Metro Martin Place

Over Station Development Design Integrity Report South Site

JULY 2020

DRP 12

Plan detail of facade alignment in approved DA design

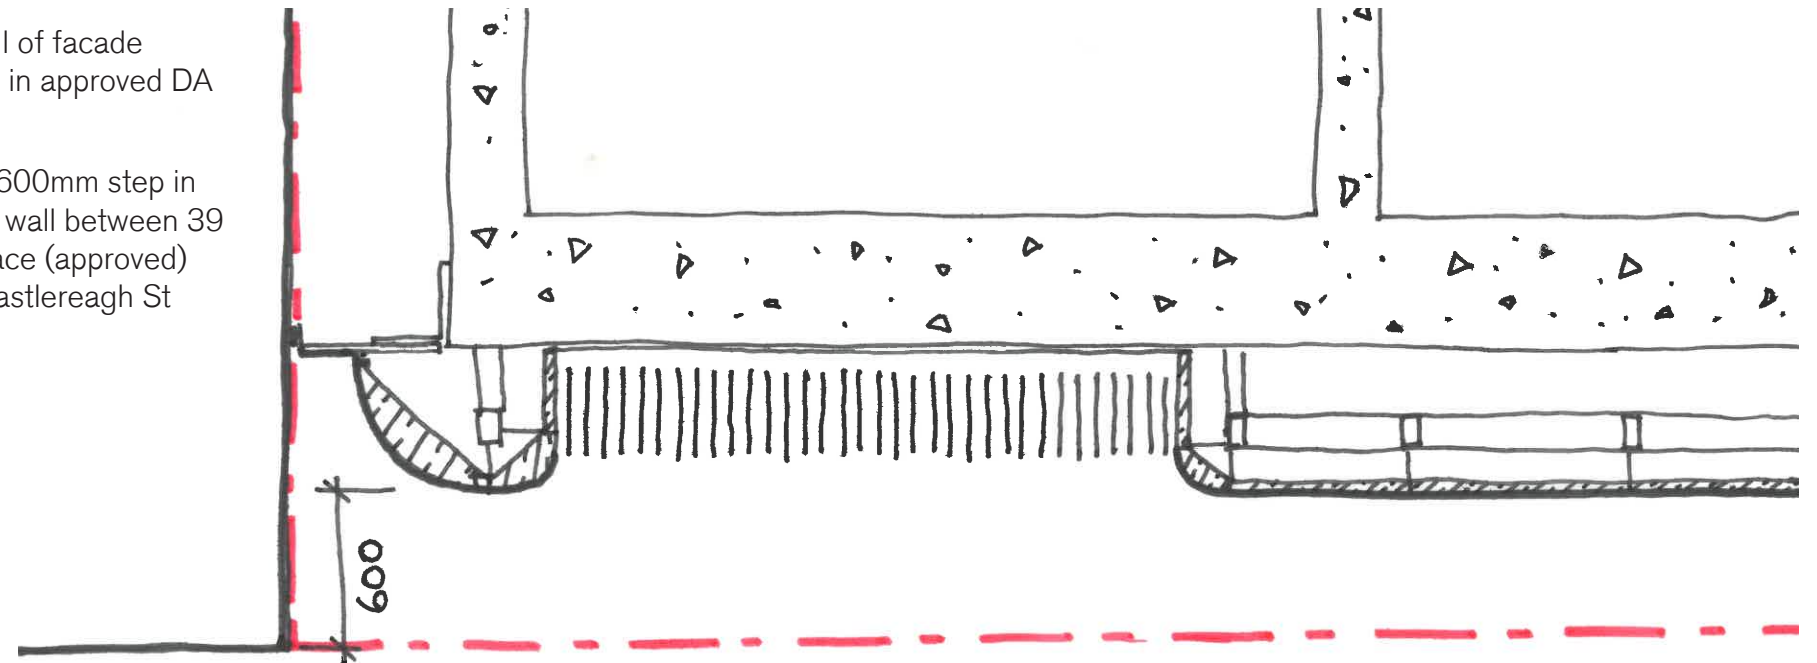
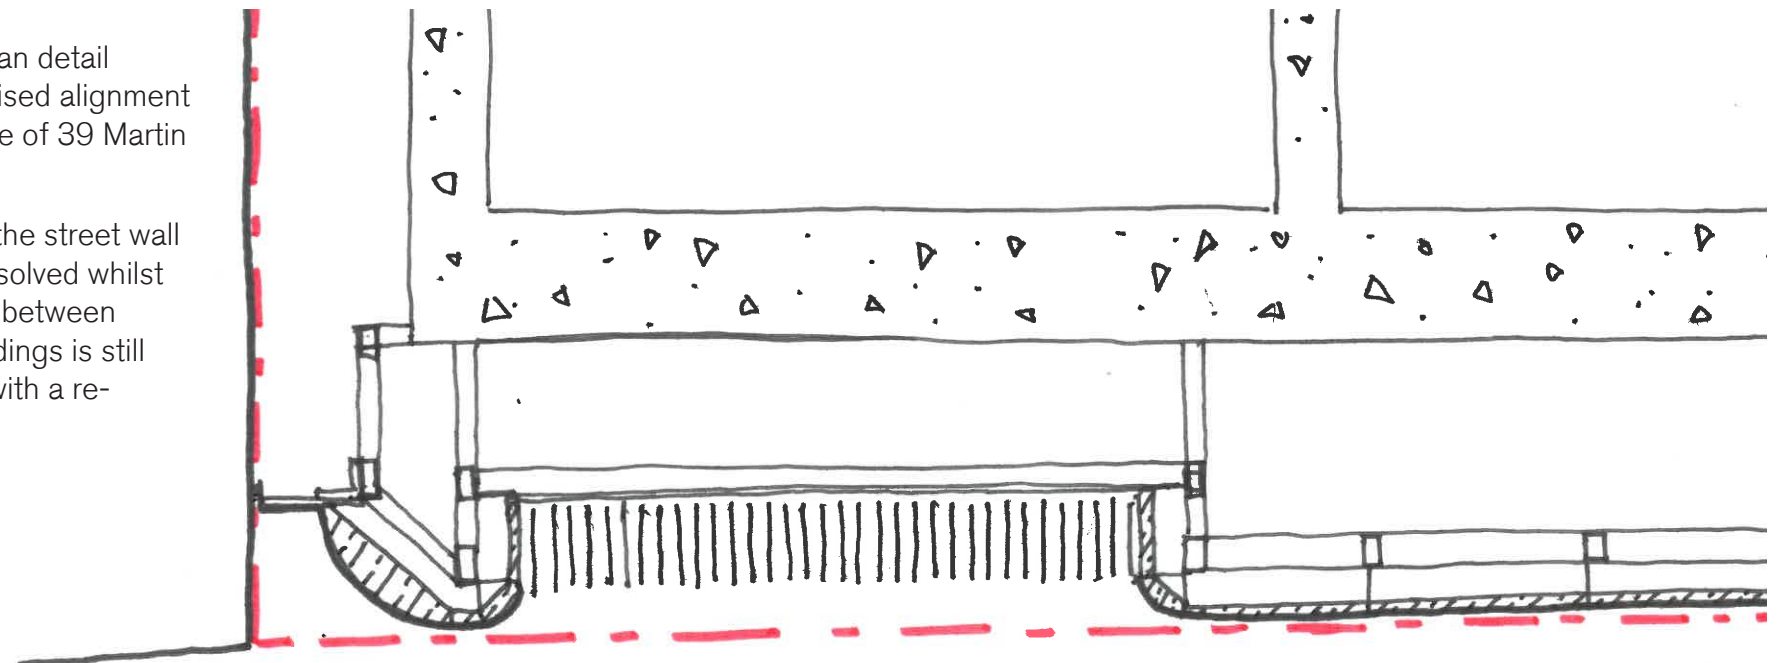
Note the 600mm step in the street wall between 39 Martin Place (approved) and 60 Castlereagh St (existing)

Tzannes explained that due to technical drafting issues the eastern façade of the South Tower does not align with the existing street wall of Elizabeth Street.

Proposed plan detail showing revised alignment of the facade of 39 Martin Place.

An amended proposal was presented which seeks to rectify the discrepancy by realigning the eastern façade with the site boundary and the dominant street wall, a change of approximately 600mm.

The panel supports this change which reflects previous discussions around the importance of the street wall and sits within the approved building envelope.

Approved DA design showing 600mm step in street wall

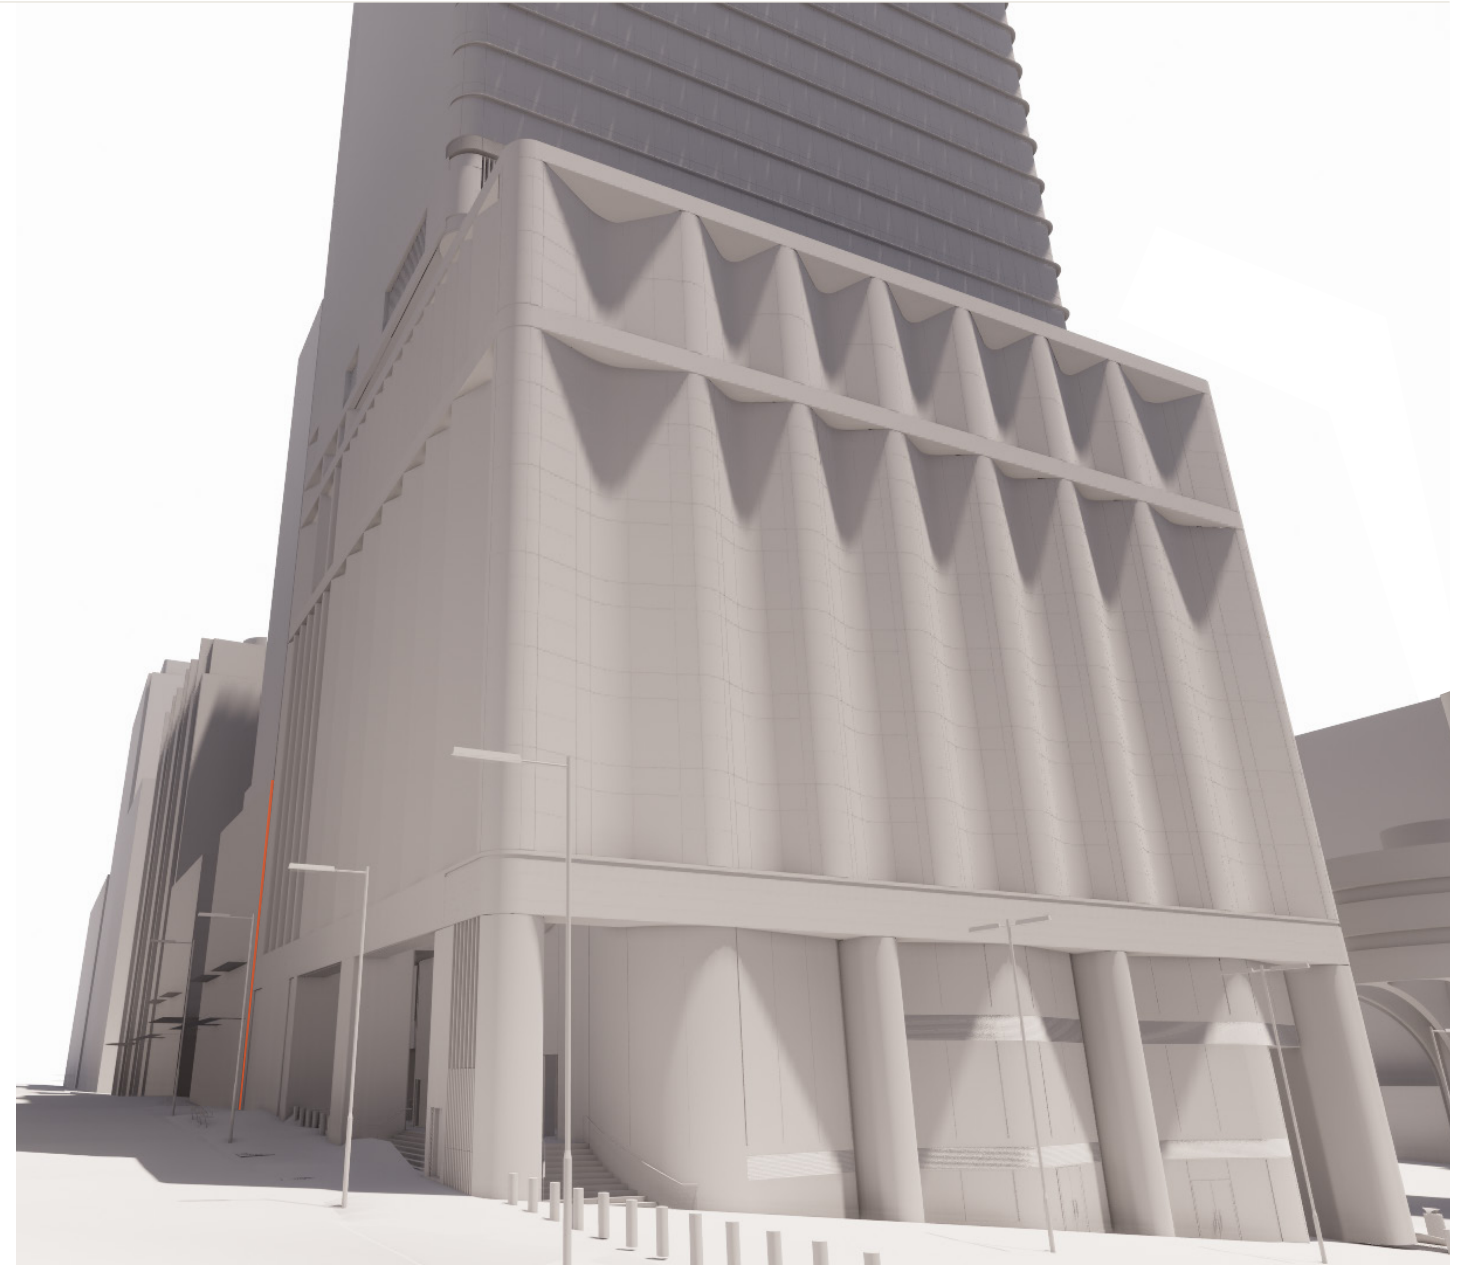
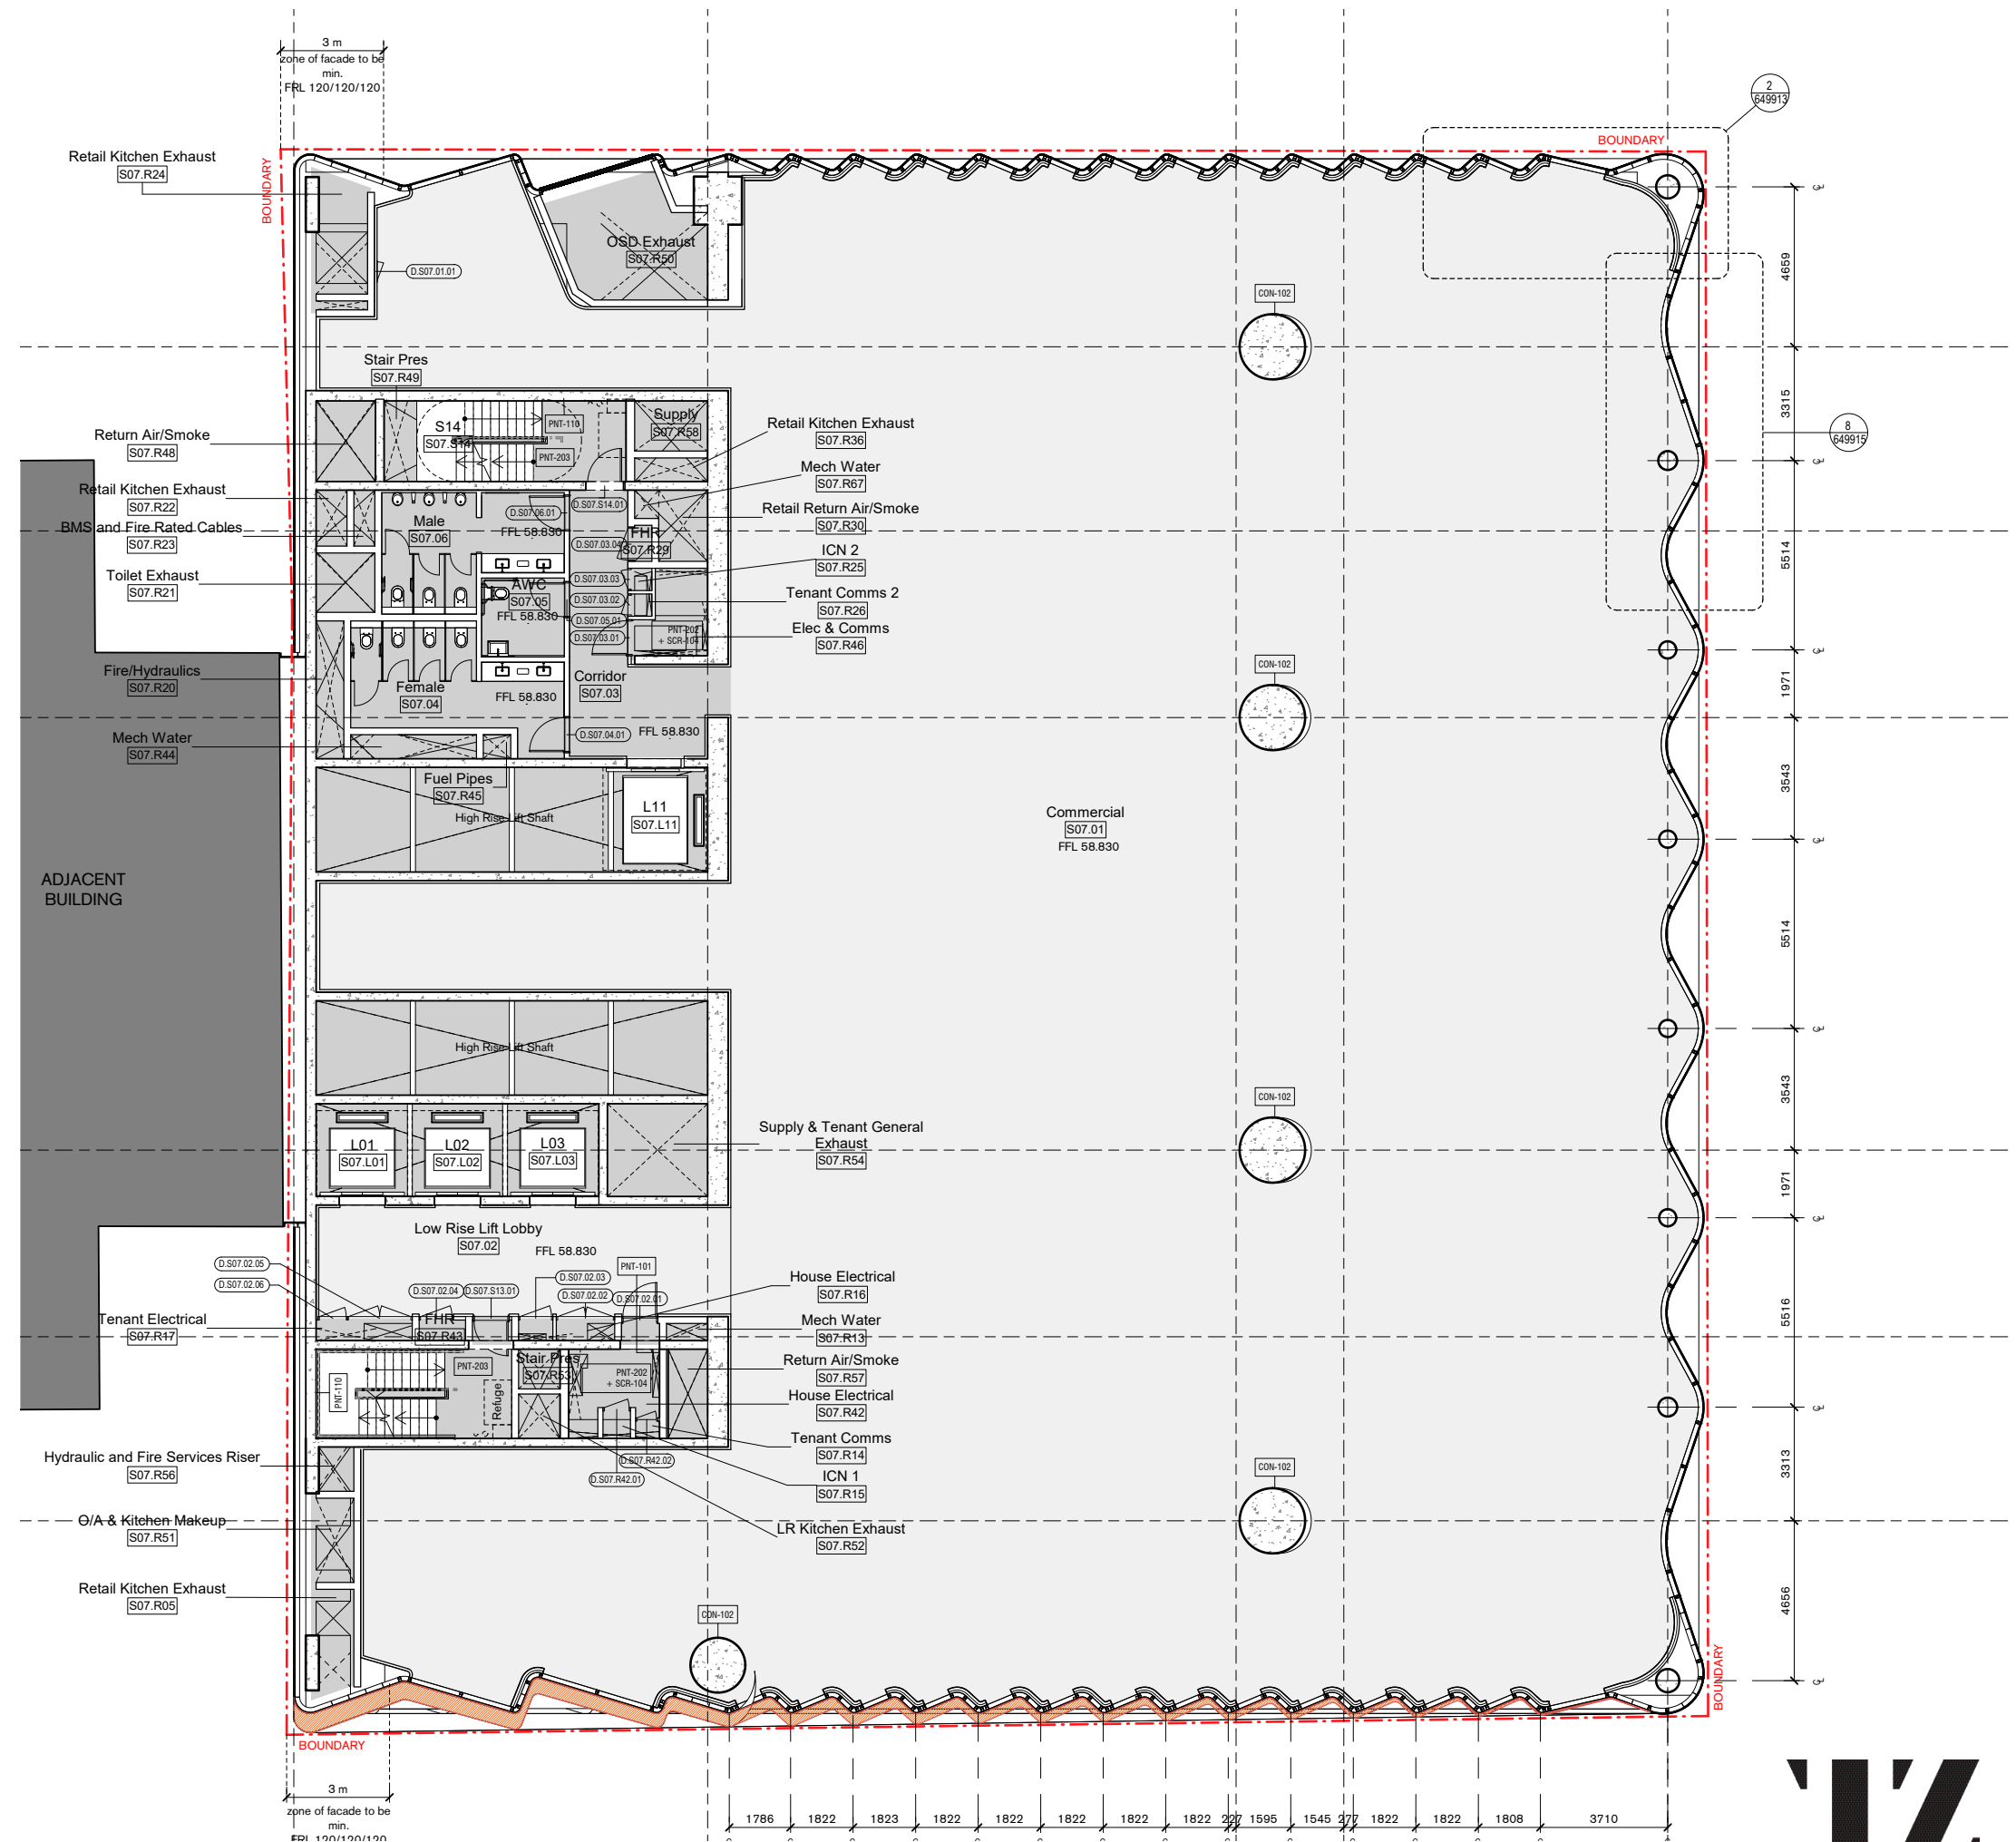
- The east facade of approved DA design for 39 Martin Place does not align with the existing street wall of Elizabeth Street.
- The existing adjacent building, 60 Castlereagh Street, is built to the site boundary. Any future development on this site is also likely to build to the site boundary in order to maximise area.
- In the existing condition, and likely future condition, there is a 600mm step in the street wall between the facades of 39 Martin Place (as approved) and 60 Castlereagh Street.

The step in the street wall has been resolved whilst the junction between the two buildings is still articulated with a re-entrant

Proposed revised design showing alignment east facade with existing street wall

Preferred Architectural Solution - double 600mm deep horizontal solar shades

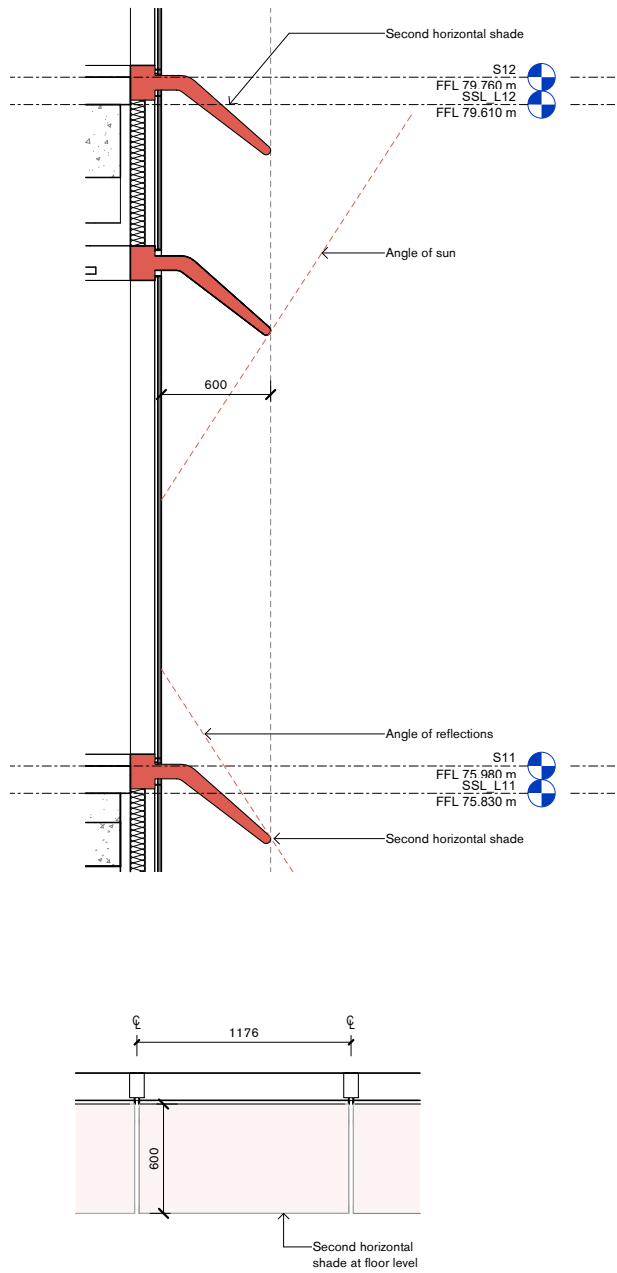
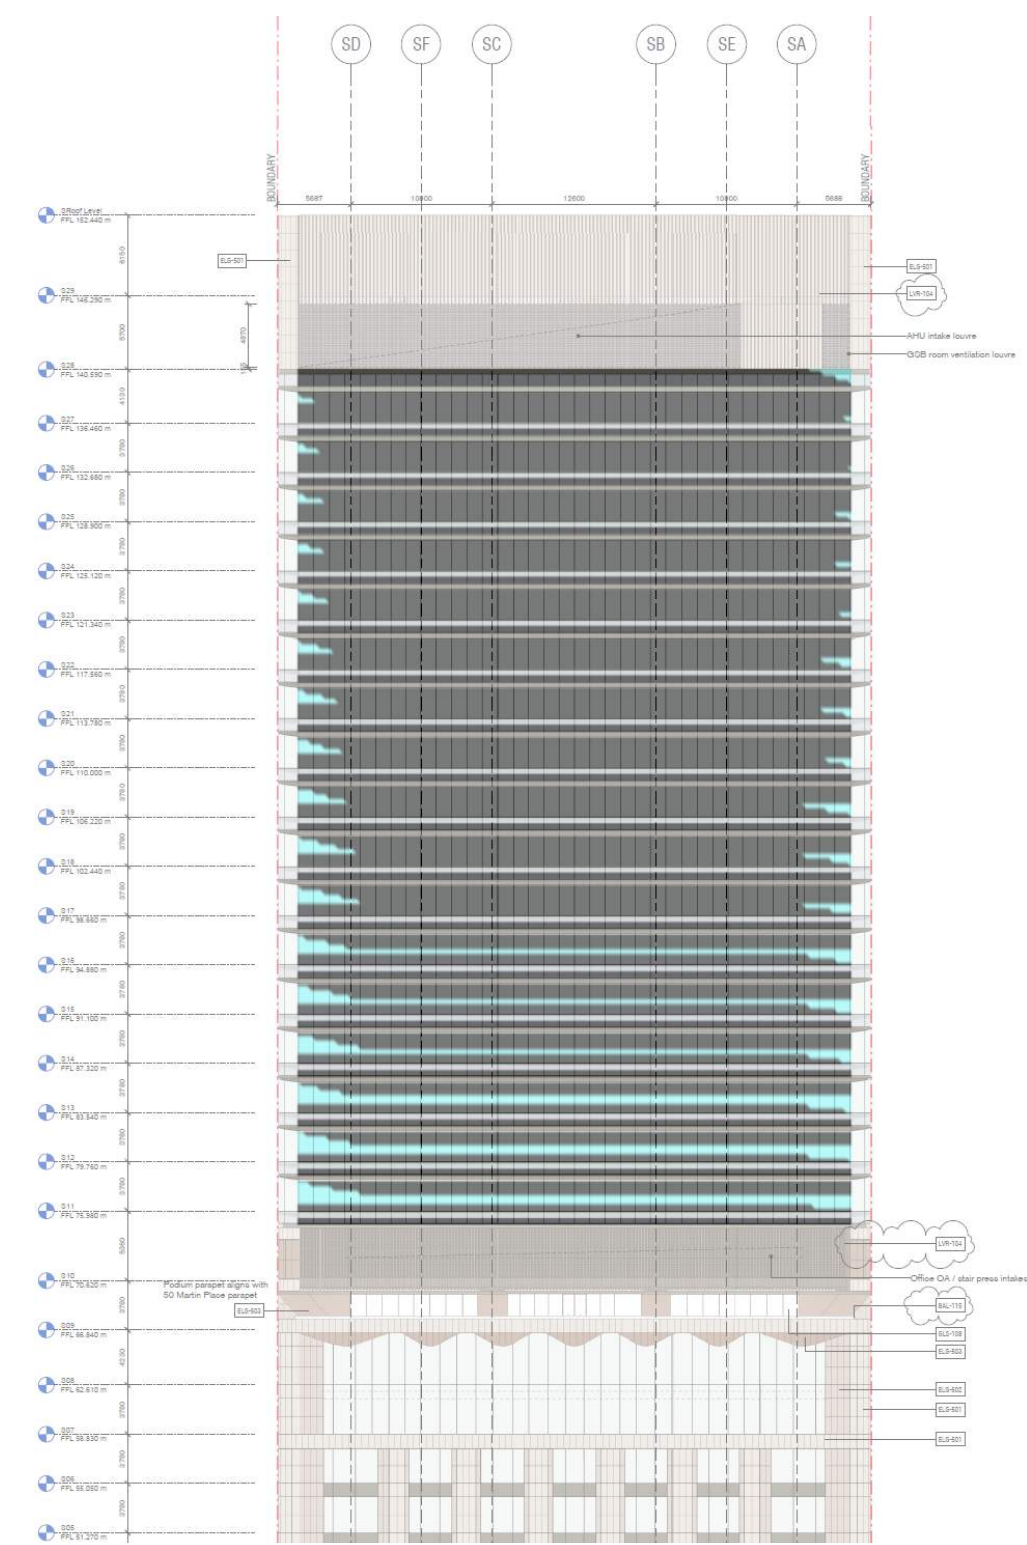
At the last DRP, the panel recommended amending the design of the South Tower by the addition of vertical fins (or any other means) to reduce or eliminate glare from the northern façade onto the western end of Martin Place near the Cenotaph. The recommendation was adopted as a Condition of Consent and DRP 12 was convened to seek the panel's endorsement of the changes and discharge the condition.

The first proposal adds vertical fins to the northern façade between the horizontal shading of the approved tower. This proposal eliminates glare completely from the critical area around the Cenotaph. Proposal two, adds a second band of horizontal shading immediately below the first. This proposal significantly reduces glare in this area.

The panel acknowledges and commends the effort of all parties to resolve this issue and endorses the addition of a second band of horizontal shading to the northern façade of the South Tower. While the change does not eliminate glare completely, there is a significant reduction. It is also understood that any remaining glare impacts are minor and will not conflict with major events associated with the Cenotaph, including ANZAC and Remembrance Days.

The panel considers the addition of a second band of horizontal shading to be a solution that reduces glare and strengthens the architectural expression of the tower.
